Addendum No. 2
March 15, 2021

Project: Jane Addams Elelmentary School – C.I.P. Addition And Renovations PD #3312
Project location: 2511 W. Brookings Street, Sioux Falls, SD 57104
Project number: 1105.2914.20

Architect: Architecture Incorporated

**UNDERFLOOR/TUNNEL PLAN - AREA
B - DEMOLITION - PLUMBING &
HEATING**

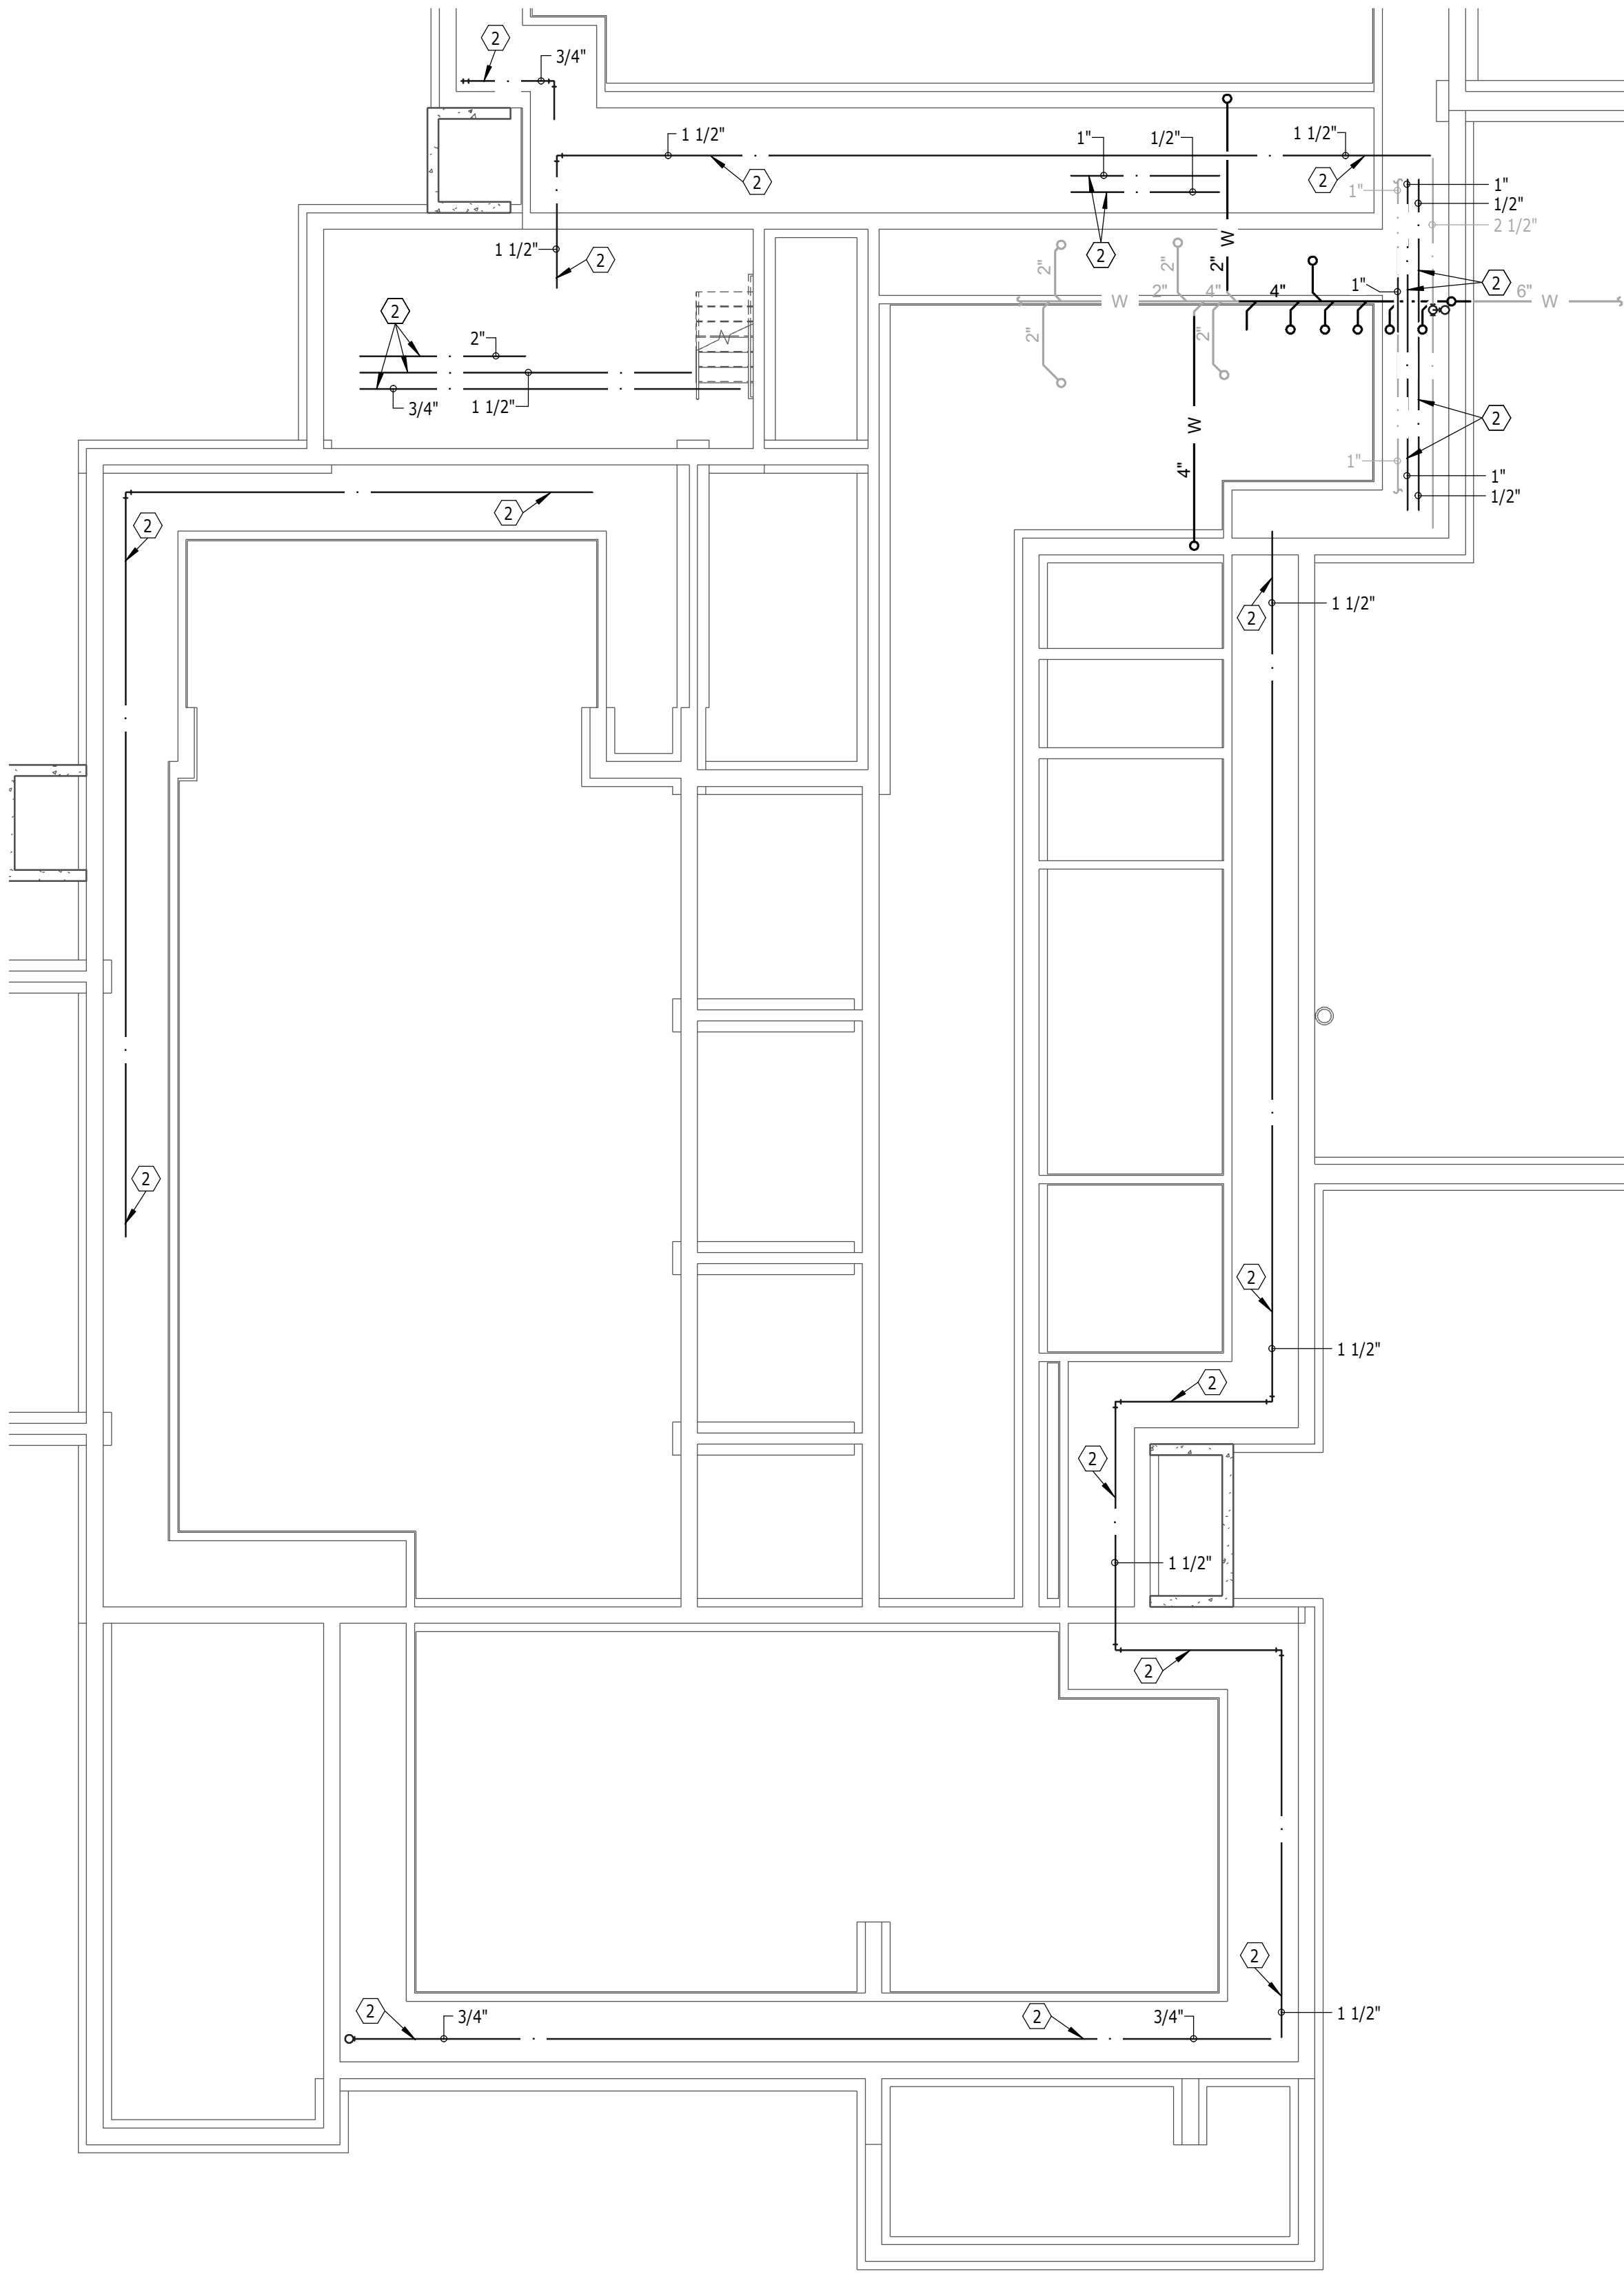
- a) Remove HWS & HWR piping mains as shown. Refer to revised drawing sheet 8.20, dated 3-15-21.
